PLANNING REPORT

Architectural Review Board

60 Franklin Street – Solar Panels 25-084ARB-MPR

Site Location Map

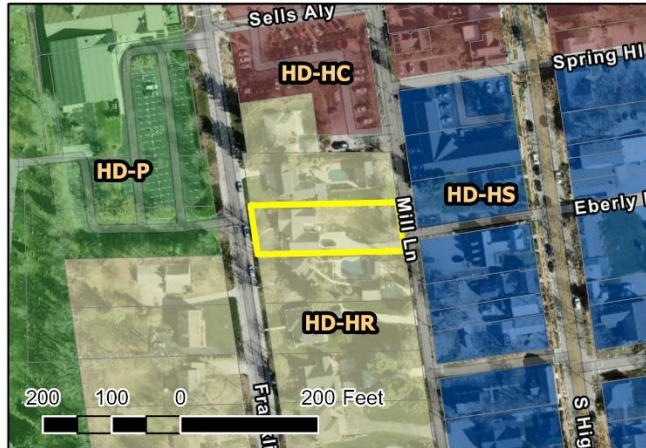
- 1 Main Structure
(Proposed Location for Solar Panels)
- 2 Mature Vegetation
